PONTIAC

Service Craftsman News

No. 7 S-285

July, 1956

Fig. 1 Overrun Clutch Valve Below 5 MPH

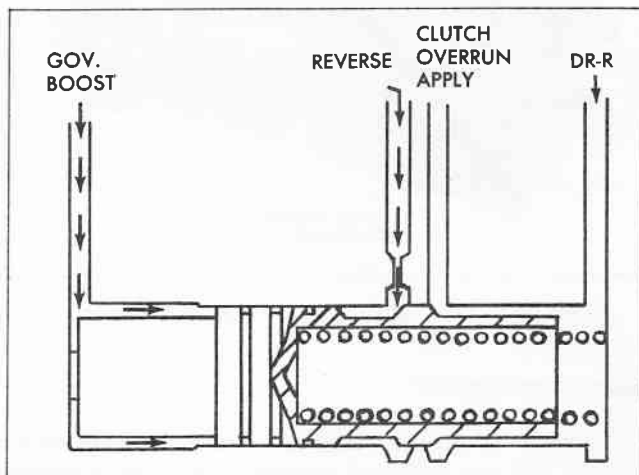
The overrun clutch valve is now controlled by governor boost pressure on one end working against a spring at the other end. At speeds under approximately 5 MPH the spring holds the valve to the left cutting off reverse oil to the overrun clutch (Fig. 1). Eliminating the overrun clutch application prevents starvation of the reverse clutch when shifting to reverse since it is not necessary to fill the relatively large volume behind the overrun clutch piston. A much firmer reverse clutch application results, which eliminates the grunt which was previously noticed in some transmissions. At speeds above 5 MPH the overrun clutch valve moves to the right to allow application of the overrun clutch (Fig. 2).

Fig. 3 Second Type Service Shift Valve Body

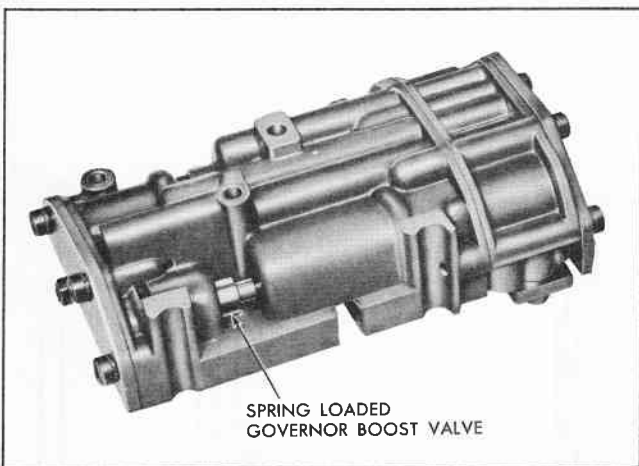
A spring has been added in front of the governor boost valve. The spring improves the operation of the valve and assists in preventing delayed 1-2 shifts with cold oil.

The 2nd type service shift valve body has the new governor boost valve with the spring which results in higher governor boost pressure than in the 1st type. If this 2nd type is installed on an assembly having the 1st type overrun clutch valve body, the spring must be removed from the governor boost valve so that it will put out the proper pressure to operate the early type coupling valves.

Service parts can be identified by the part numbers listed above. Visual inspection of the shift valve body on the transmission will show whether it is the 2nd type (with spring) or the 1st type (no spring). The valve will appear as shown in Fig. 3 on the 2nd type and the spring tension can be felt. On the 1st type the valve may or may not be visible, but it will be obvious that there is no spring tension.

Fig. 4 Second Type Service Overrun Clutch Valve Body

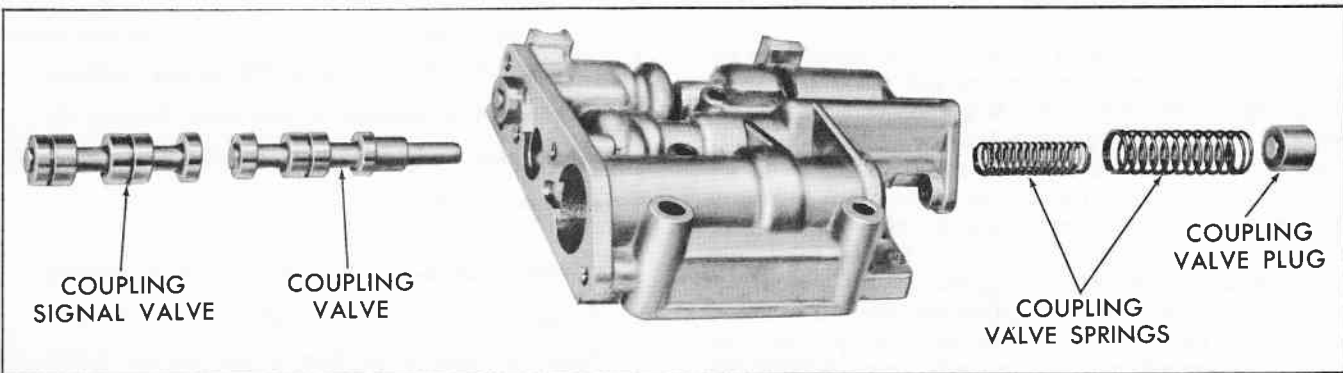
The coupling valve has been redesigned to further aid in preventing delayed 1-2 shifts with cold oil. The new coupling valve assembly has two springs, and a larger diameter plug.

When the 2nd type service overrun clutch valve body is installed in place of the 1st type, the shift valve body must also be changed to the 2nd type.

When it has been determined which type shift valve body is on a control valve assembly, it can be assumed that the overrun clutch valve body is of the same type. If necessary to determine the type of overrun clutch valve body, the only method is by removing the rear plate which compresses the limit valve springs. It can then be determined whether the coupling valve plug is the 2nd type and whether there are one or two coupling valve springs (Fig. 4).

Fig. 5 Overrun Clutch Valve Body

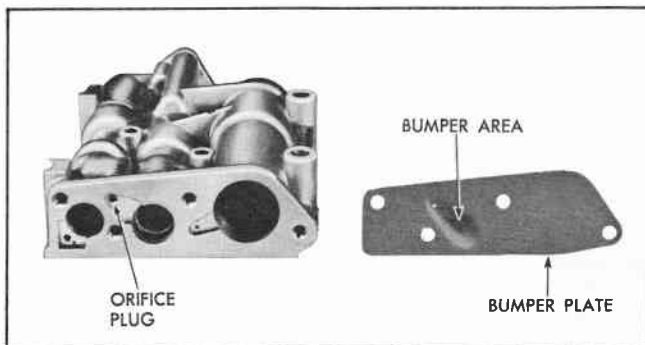
A few cases have been encountered where the Strato-Flight transmission will emit a clicking noise when operating at very low speeds. The noise will usually occur just before the transmission shifts from 1st to 2nd, and is made by the coupling valve.

It is caused by variations in G-1 pressure due to the effect of the weight of the G-1 valve when it rotates from top to bottom. These pressure variations are amplified by the governor boost valve and directed to the end of the coupling valve. The coupling valve will be caused to oscillate, striking the overrun clutch valve body front plate and giving out a clicking noise.

This clicking noise can be eliminated by the installation of "Transmission Control Valve Body Repair Kit" Part No. 8616949. The repair kit consists of an orificed plug to reduce the pulsations in governor boost pressure at the coupling valve and a bumper plate to cushion the oscillations of the coupling valve.

The orificed plug should be installed in the governor boost passage in the overrun clutch valve body as shown in Fig. 5.

The bumper plate should be installed under the front plate of the overrun clutch valve body so that the coupling valve will strike it instead of the plate.

Fig. 6 Transmission Case

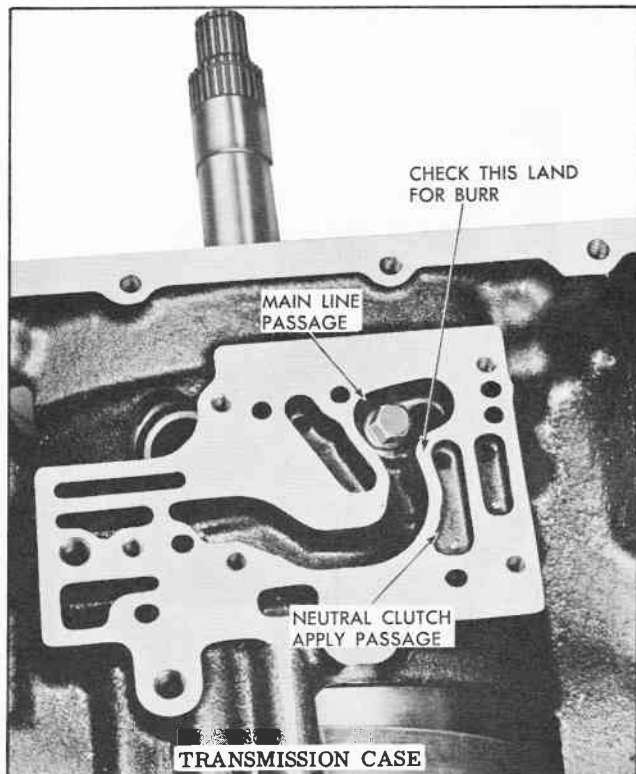
Several instances have been reported in which Strato-Flight transmissions lock up when shifted from drive or low range to reverse, but shift normally from neutral or park to reverse.

Investigation of this complaint has disclosed a nick or burr on the case land shown in Fig. 6. This nick allows main line pressure to bleed into the neutral clutch apply passage. The effect of this leak is to slow down the release of the neutral clutch causing a momentary lock-up when the transmission is shifted from drive to reverse.

When a complaint of this nature is encountered, remove the control valve assembly and check for damage at the location shown in Fig. 6. If a burr is found, remove it by stoning. Also check the spacer plate and replace it if it has been damaged by the burr.

Fig. 7 Cutaway View of Strato-Flight Hydramatic

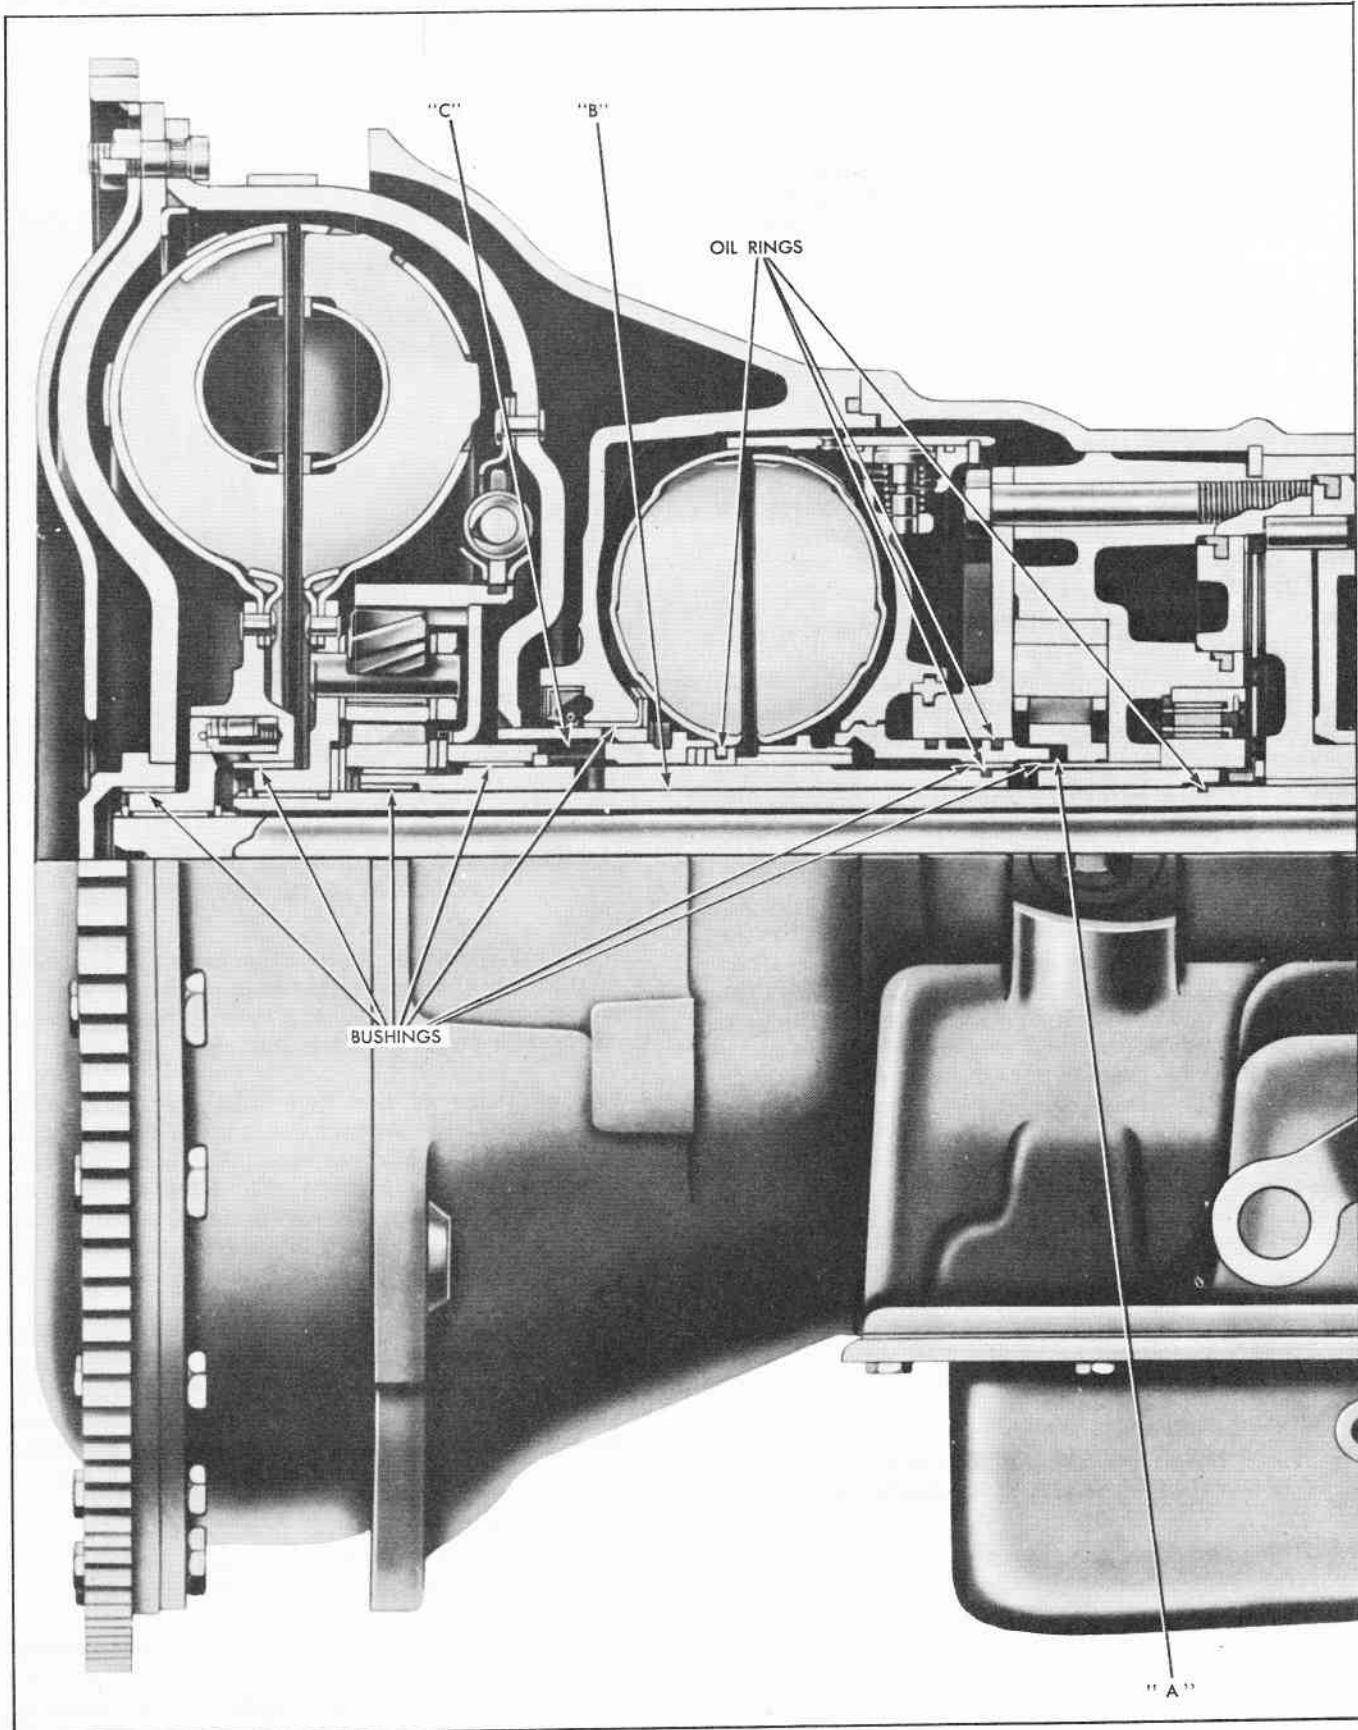
Occasionally a Strato-Flight Hydra-Matic transmission is encountered which will not drive the car for several seconds after the engine is started. This condition is usually noticed when the car has been parked for a considerable time, such as overnight.

The momentary failure to drive may be caused by the fact that a large portion of the fluid has drained back from the main fluid coupling. Since the points of leakage which have caused the fluid to drain back will also leak when the coupling is being filled, there will be a delay in refilling the coupling when the engine is started. As soon as the coupling is filled, it will function satisfactorily until it has again been parked for several hours.

Torus feed oil which originates at the front pump, passes through the torus feed valve to the oil cooler and then back through the pump cover to emerge into the torus supply line at "A" in Fig. 7. The oil then passes around the rear end of the front unit coupling cover, through holes in the front unit driven torus shaft and into space "B" around the intermediate shaft.

Oil passes forward along the outer diameter of the intermediate shaft to the holes near the front of the front unit coupling driven torus shaft. From there the oil passes up around the front end of the front unit coupling drive torus hub, between the hub of the internal gear and the hub of the torus cover (area "C"), and into the main torus.

Careful study of Fig. 7 will reveal the bushings and oil rings which control the flow of oil from the pump to the torus members. They are as follows:

While it is considered that oil is sealed by the above mentioned bushings and oil rings, actually there are "controlled leaks" at all these points. If the clearances become excessive, however, due to wear or damage, the leaks can become great enough to impair the filling of the torus. The result will be excessive drain back, slow filling, and a delay in drive after starting the engine.

Fig. 8 Sun Visor Center Bracket Comparison

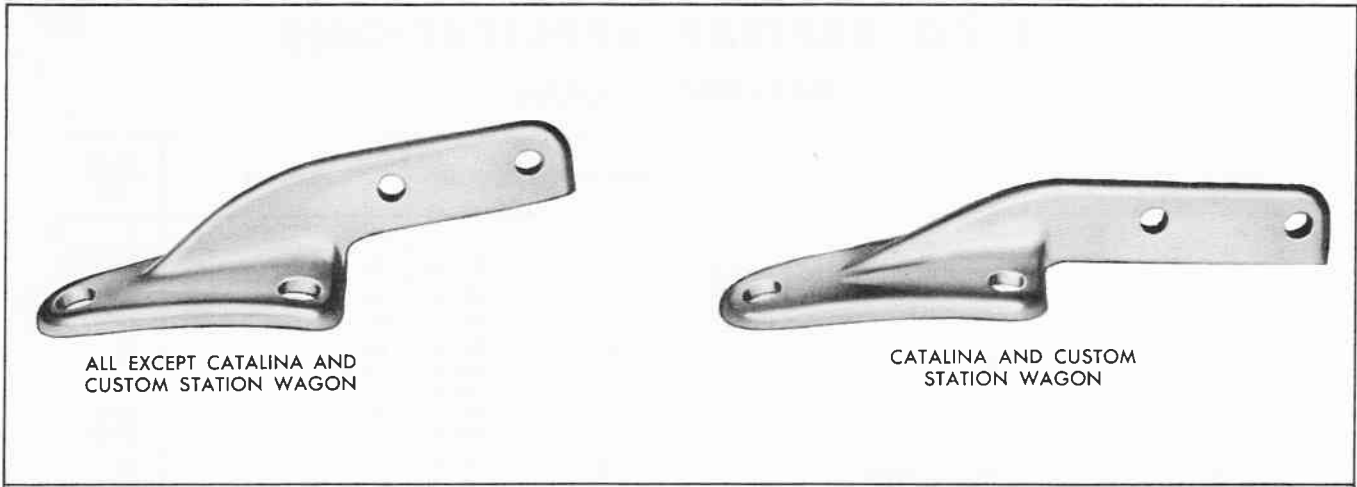
Reports of noisy outside sun visors have been received. Our investigation of these reports show that visor location is very critical with respect to wind noise and that noise will be eliminated if the visor is installed to the correct dimensions. Another cause of dissatisfaction can be eliminated if care is taken that the correct sun visor center bracket is used. Two brackets are available -- one for Catalina and Custom Station Wagon Models and one for all other models (Fig. 8). It is impossible to get a quiet satisfactory installation if the wrong bracket is used.

Fig. 9 Visor Installation Gauge

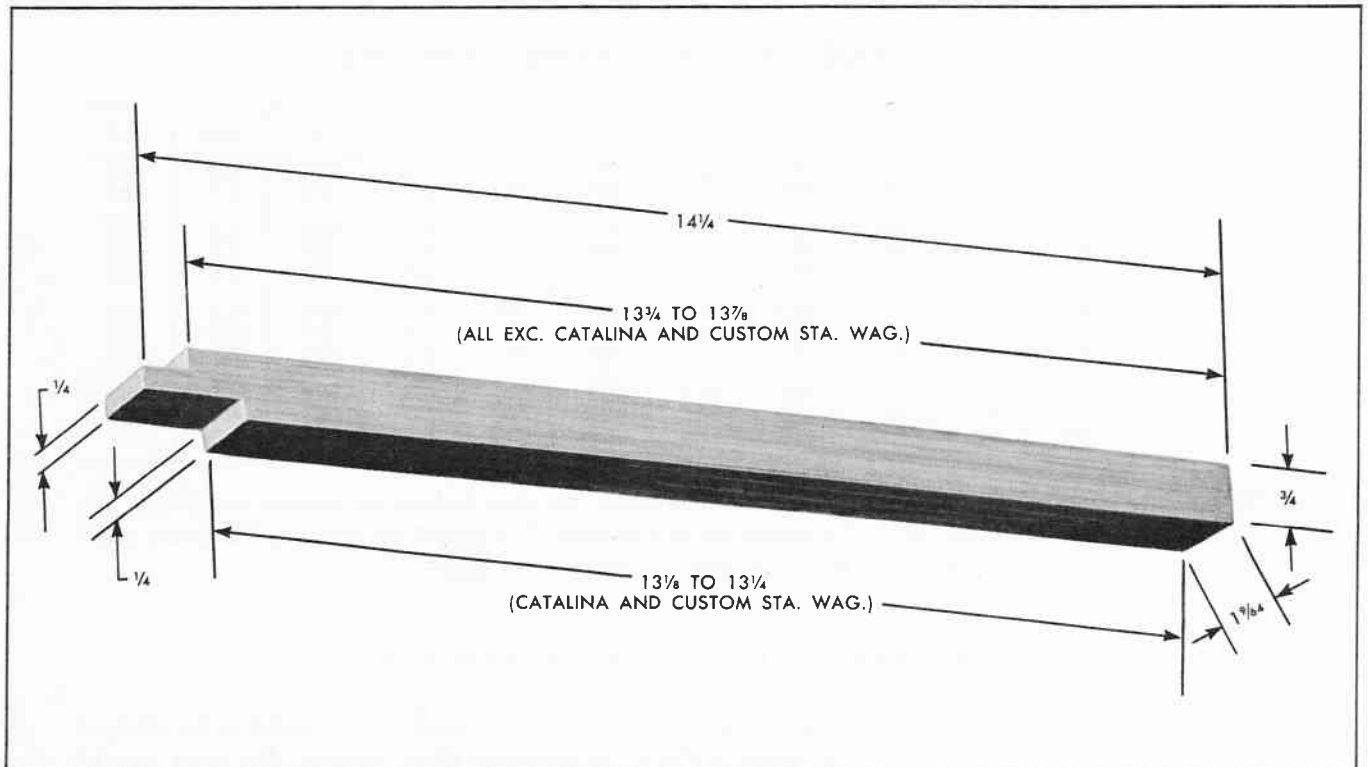
To aid in correct installation, it is necessary that a wooden gauge, as shown in Fig. 9, be used. Quiet visor installation cannot be made without this gauge. The gauge can also be used to check existing installations for correct dimensioning. Note that the gauge is so designed that it can be used on all models by merely changing sides. Fig. 10 shows the gauge position for measuring the height of leading edge of the visor on a four-door sedan. On a Catalina or Custom Station Wagon the other notch would be used.

Proper use of this gauge will eliminate visor noise complaints. Visor installation instructions are being re-written to include the use of this gauge.

Fig. 11 Measuring Clearance Between Roof Panel and Visor

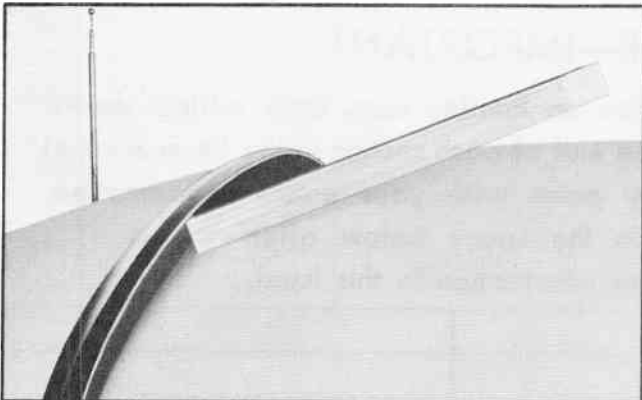
Fig. 11 shows the gauge being used to measure the clearance between the roof panel and the visor

at the rear center. In this instance the gauge should not enter between the roof and visor.

Fig. 12 Bushing Installed in Carter 4-Barrel Carburetor

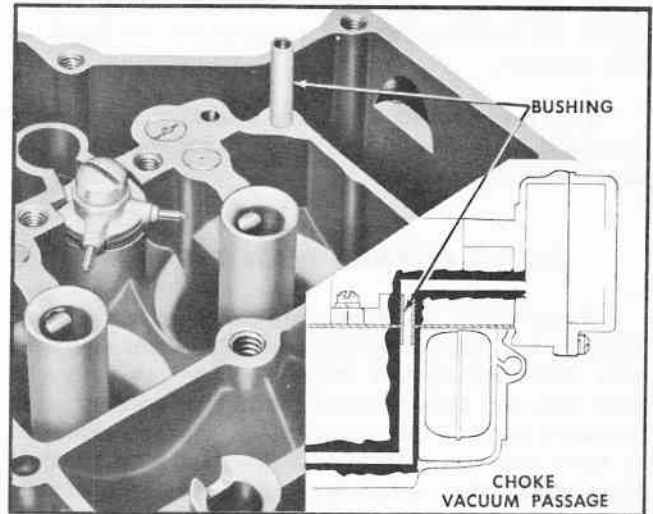
Product Information Reports have been received stating that some Carter four-barrel carburetors have a tendency to "cut-out" on sharp left turns. Investigation of this condition showed the primary cause to be a leakage of fuel from the carburetor bowl to the choke vacuum passage shown in Fig. 12.

In some instances it is only necessary to tighten the bowl cover attaching screws to eliminate this condition. If this does not correct the complaint, it may be necessary to install a bushing (or standpipe), as shown in Fig. 12. Installation of this bushing assures a more positive seal and prevents fuel leaking into the vacuum passage on left turns. This bushing is released for service under part no. 3732788, and should be ordered through regular channels.

To install the bushing, remove the bowl cover and lightly tap bushing into place in the vacuum passage shown in Fig. 12. Inspect sealing surfaces of bowl cover and bowl for nicked or dented gasket surfaces and in all instances use a new bowl cover gasket. Reinstall bowl cover, tightening the inner attaching screws alternately and securely before tightening the outer screws.
